Application Number: 10/612,254

Appellant(s): LAMBRIGHT, MICHAEL

EXAMINER'S ANSWER

Claims 1, 3-9, 11-22 is rejected under 35 U.S.C. 102(b) as being anticipated by Chandler (US 3,760,965).

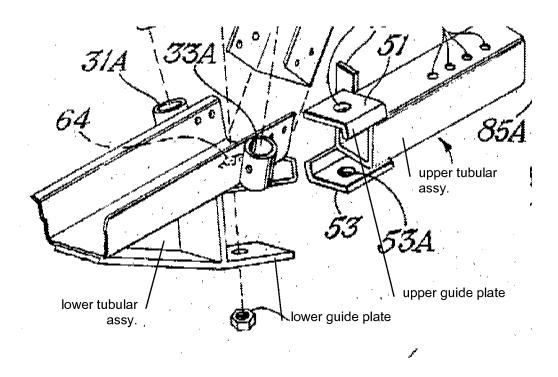
interpretation, there must merely be structure that is cylindrical but does not have to be a tube. With respect to FIG. 6 reproduced below Chandler discloses tubular structure defined by plates 23, 61 & 63 clearly define tubular structure, i.e. "consisting of a tube".

Chandler's plates 23, 61, 63 clearly have the form of a "hollow elongated cylinder".
"Isolating" Chandler's upper tubular member is irrelevant because Chandler's lower tubular assembly is "lower" insomuch as it is below support arm 23 and because it is attached to lower guide plate. Chandler's upper tubular assembly is "upper" because it supports upper guide plate 51. And, "upper" and "lower" without regard to other structure is interpreted as disclosed by the cited prior art. Chandler's upper tubular assembly is at least above upper guide plate 53, upper guide plate 53 is at least above lower guide plate 59 and lower tubular member (indicated generally as 61) and lower guide plate are at least below arm 23. Appellant intends that the tubular members and

Appellant argues that Chandler's tubular structure must be separate from that of other structure, that plates 61 & 63 cannot utilize channel 23 to complete the tube. The claims do not recite specific features of the tubular structure, i.e. tube, walls etc. Chandler's arm includes upstanding, angled walls and a base. The base of arm completes Chandler's tubular structure whereas arm comprises upstanding, angled portions. Chandler's tubular assembly 61, 63 is coupled to channel 23 thus completing the third side of lower tubular assembly. Given Appellants definition for tubular one skilled in the art would logically conclude that a third plate is unnecessary additional expense and merely connect sides 61 and 63 to arm 23 eliminating expense.

Chandler's central axis 65 is supported by both tubular members and guide plates as shown above. In addition, lower tubular assy, and guide plate rotate relative to upper tubular assy, and guide plate. FIG. 16 discloses relative motion between lower tubular assy, and guide plate about a common axis as well as a central axis of pivot 55, 65.
